AJHajh-20220125-ArunCrem Planning Response_LPA.docx

Y/ 184/ 21/ DOC – CONDITIONS 8, 9 AND 10: DRAINAGE RESPONSE

Thank you for returning comments from your Drainage Engineer pertaining to planning conditions 8, 9 and 10 under planning permission Y/184/21/DOC for the Crematorium, Bognor.

Project No.	Originator	Volume	Lvl/Loc	Type	Role	Number	Rev
13591	CRH	XX	XX	DR	C	5310	P1

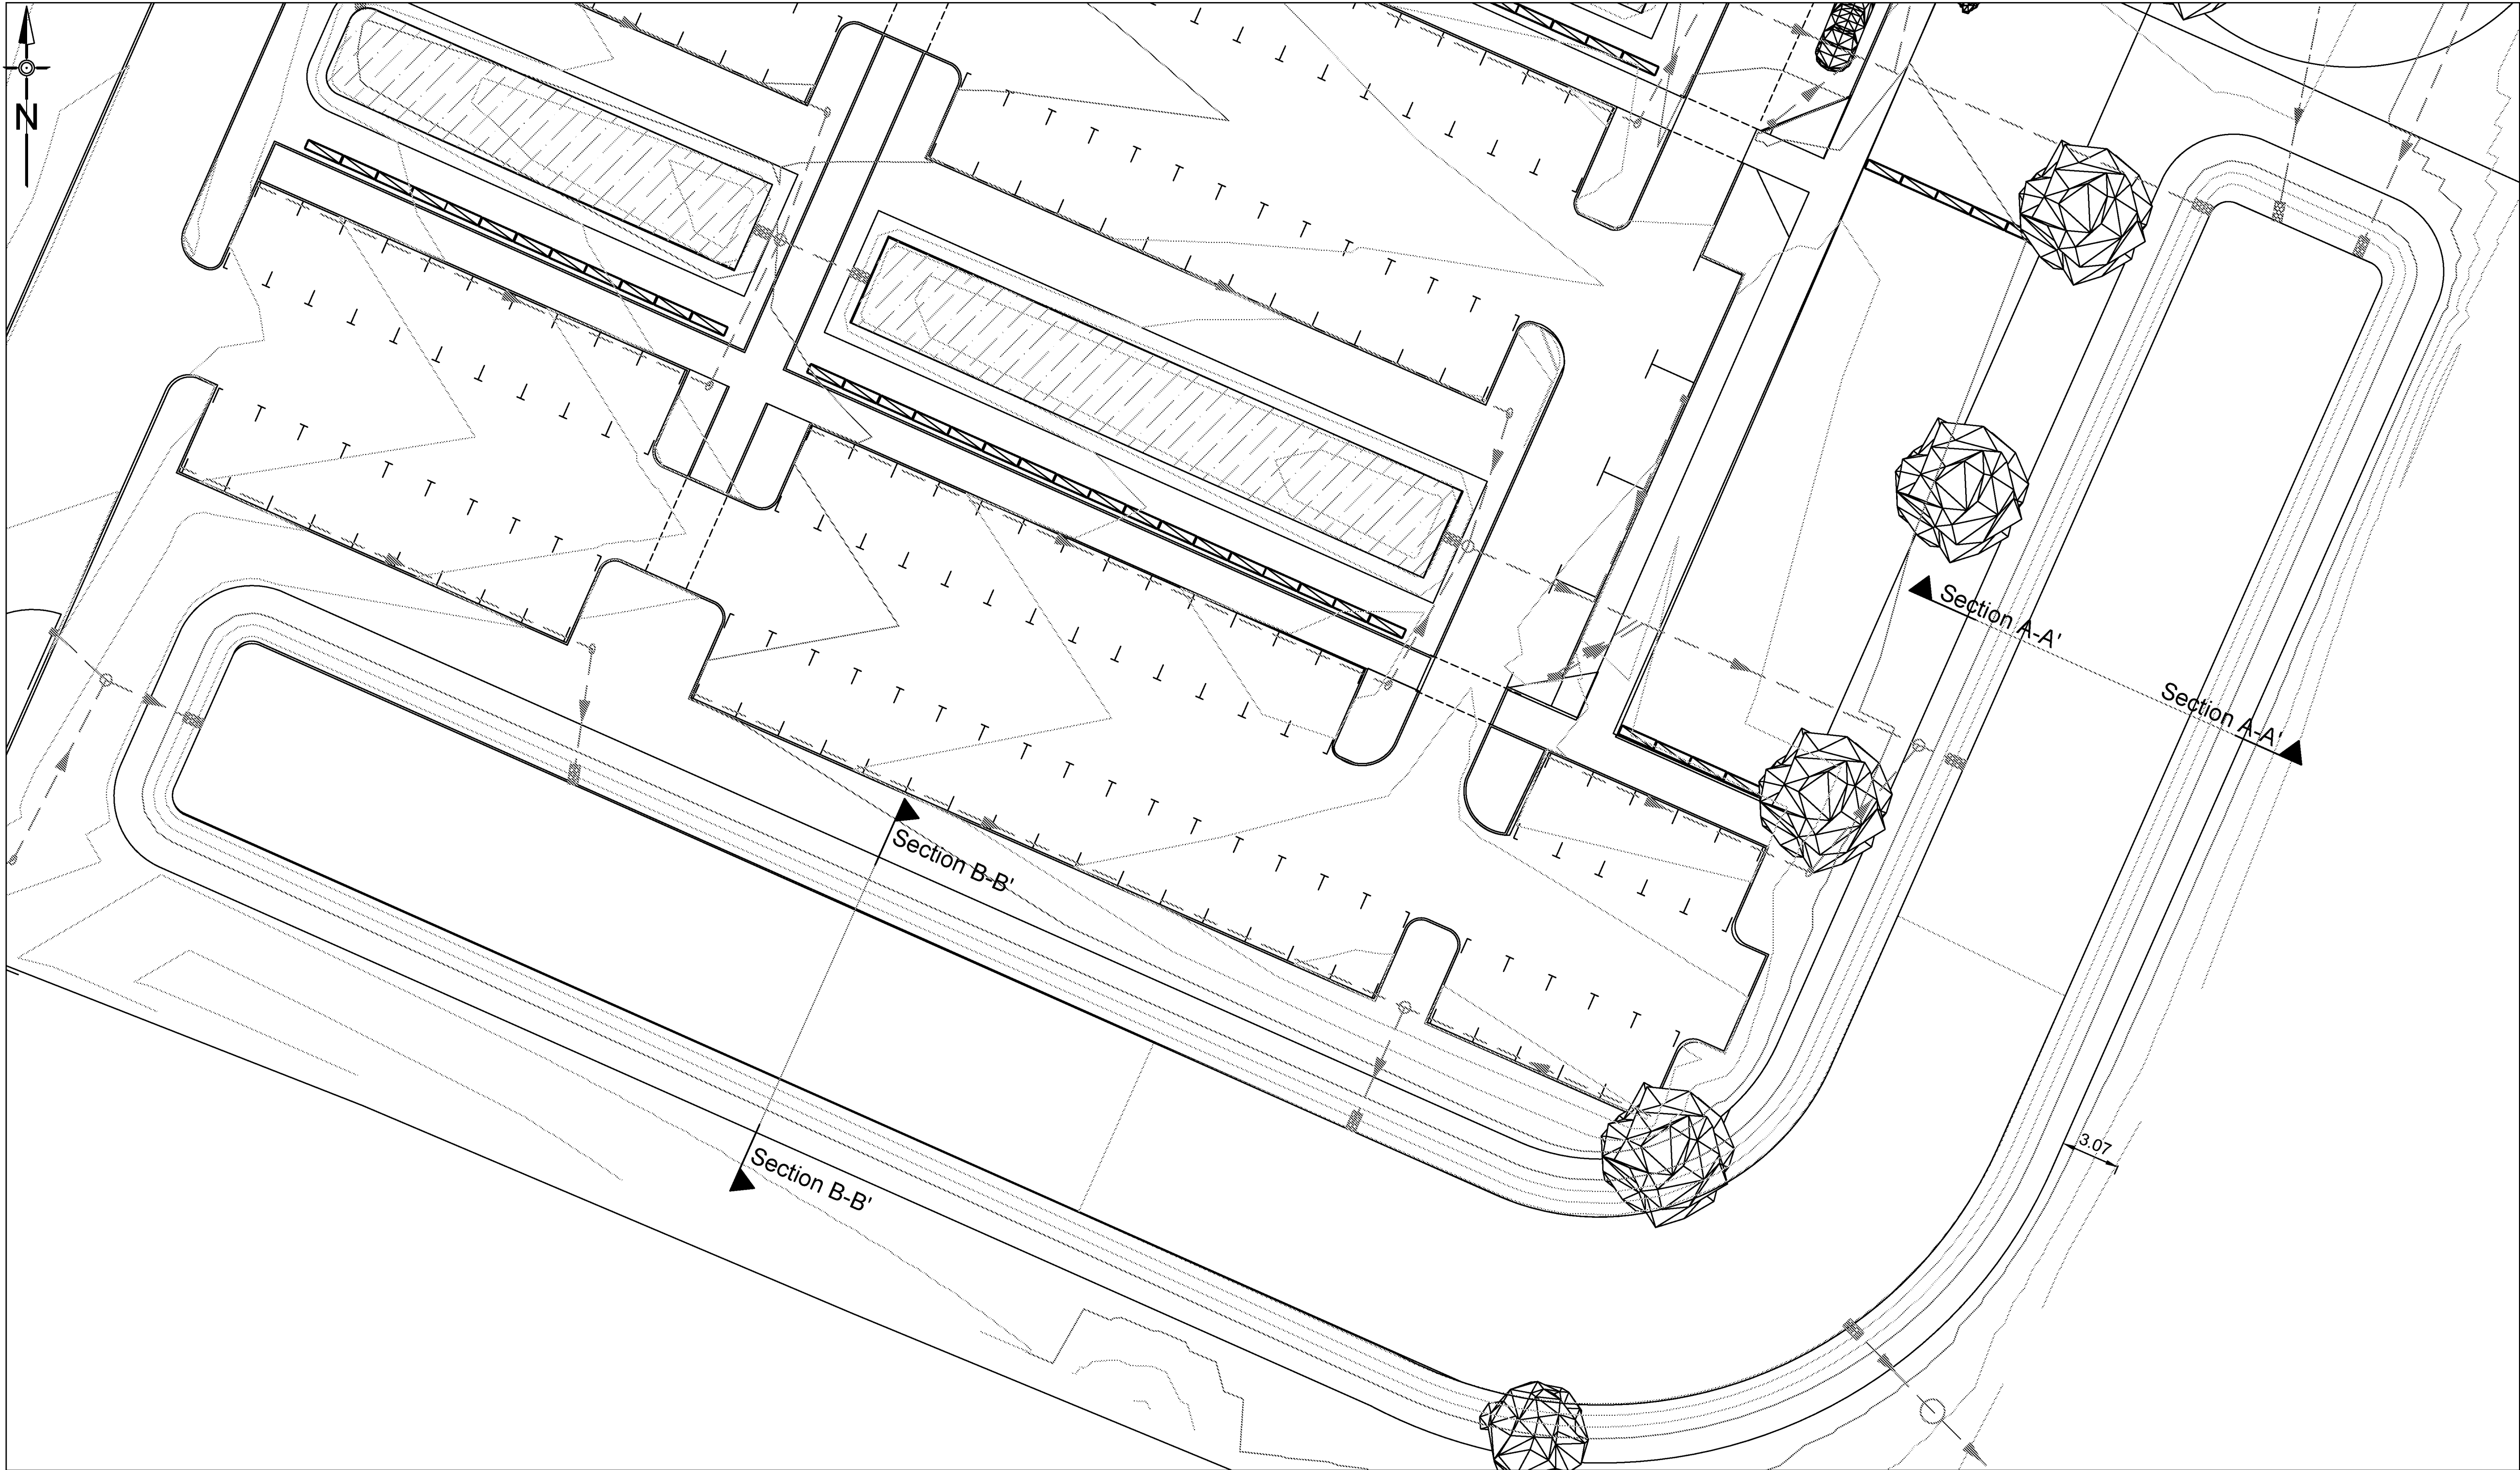
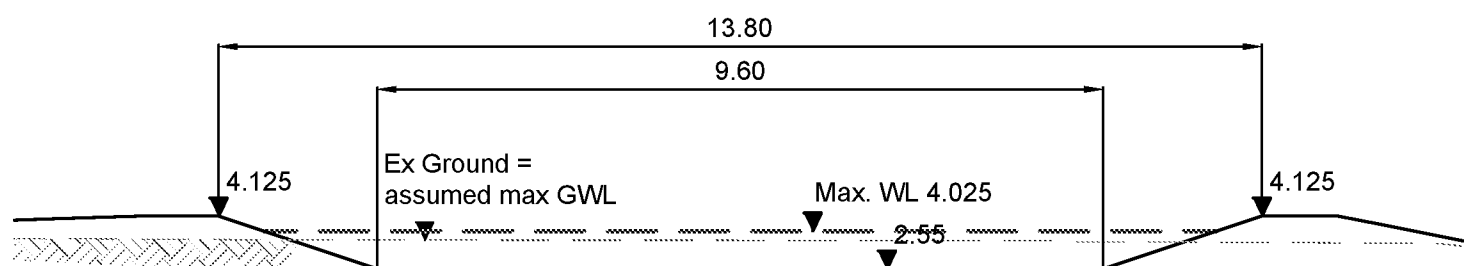
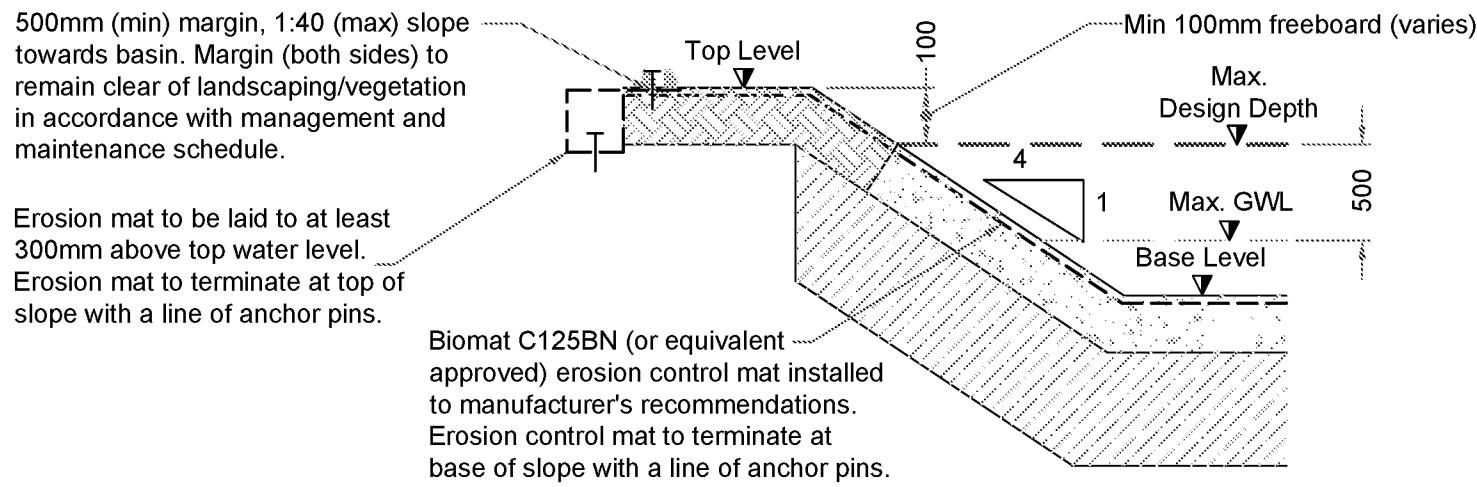
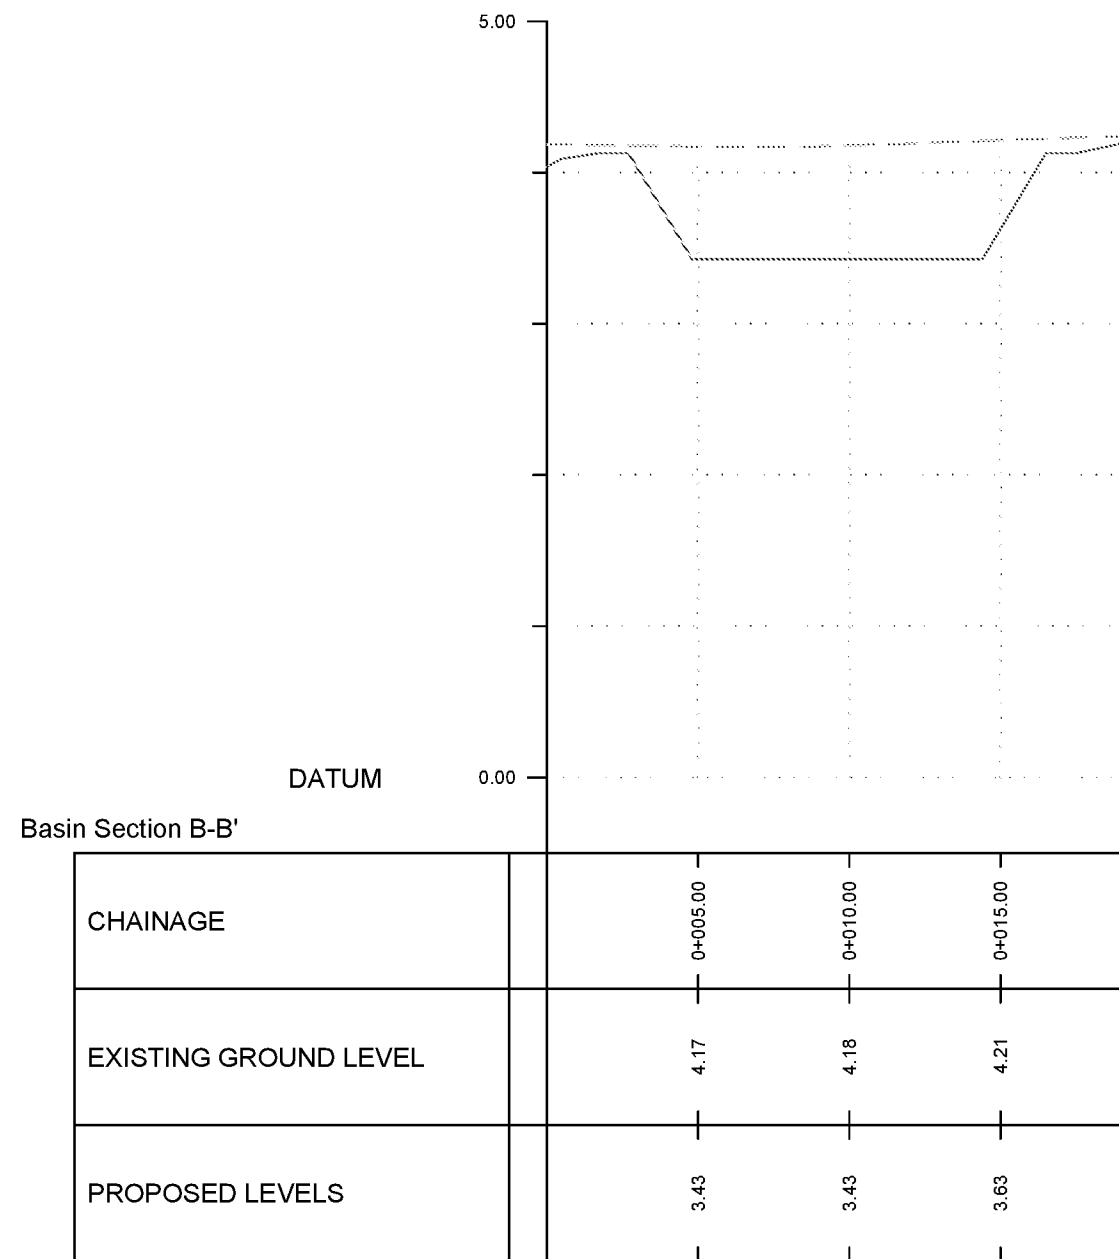
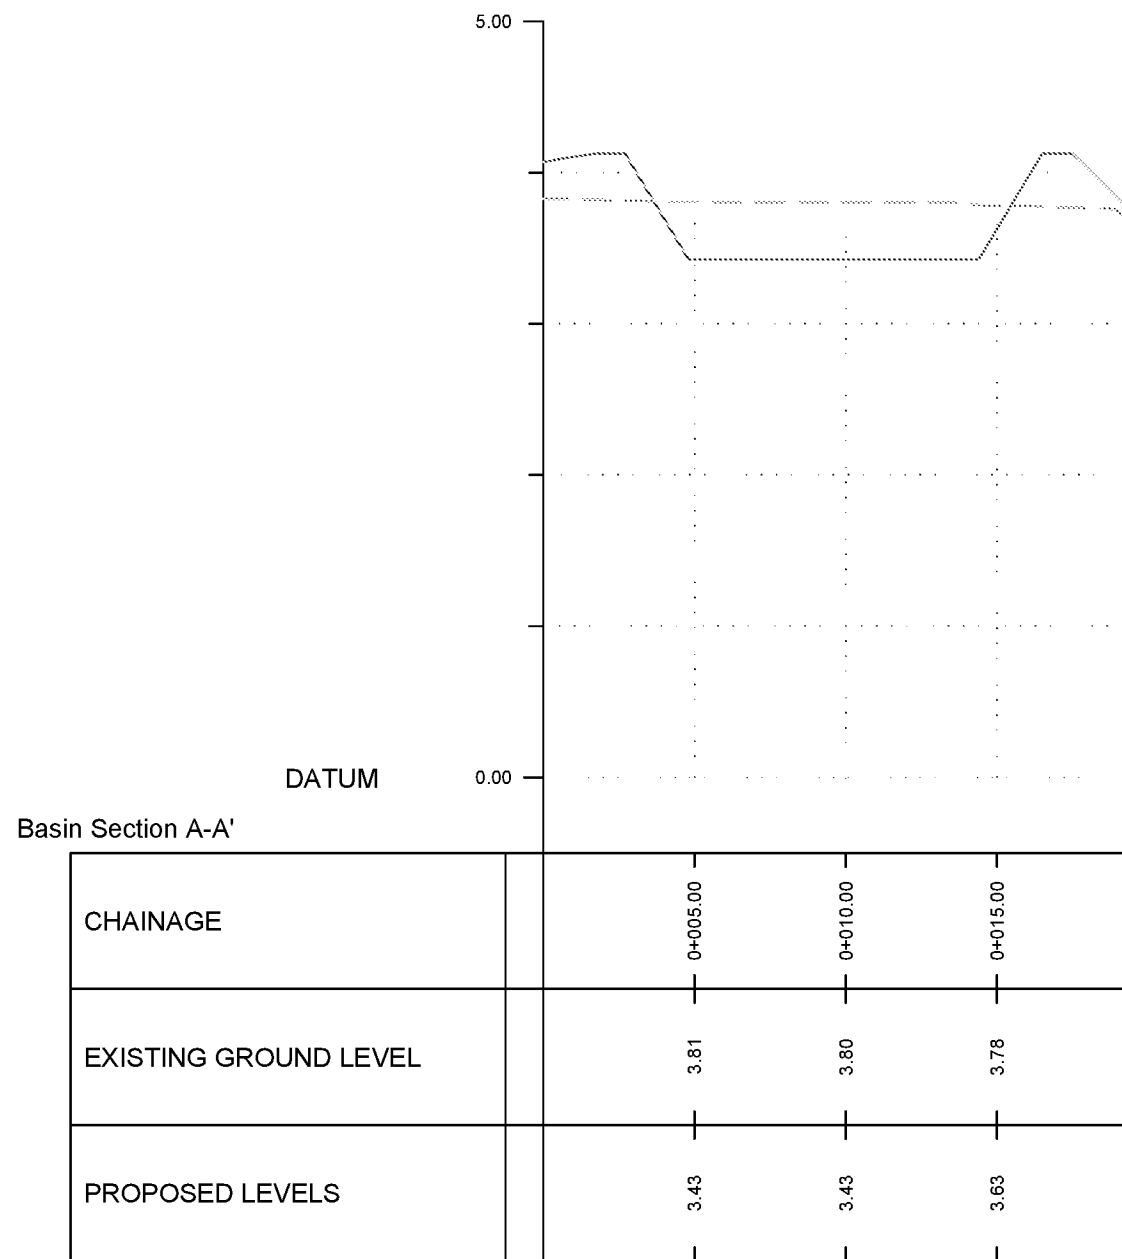
9. Please supply site specific construction details of the attenuation basin, showing invert level, top of bank level, width at bed and width at bank.

9. Please see enclosed basin detail drawing *13591-CRH-XX-XX-DR-C-5310 Revision P1*.
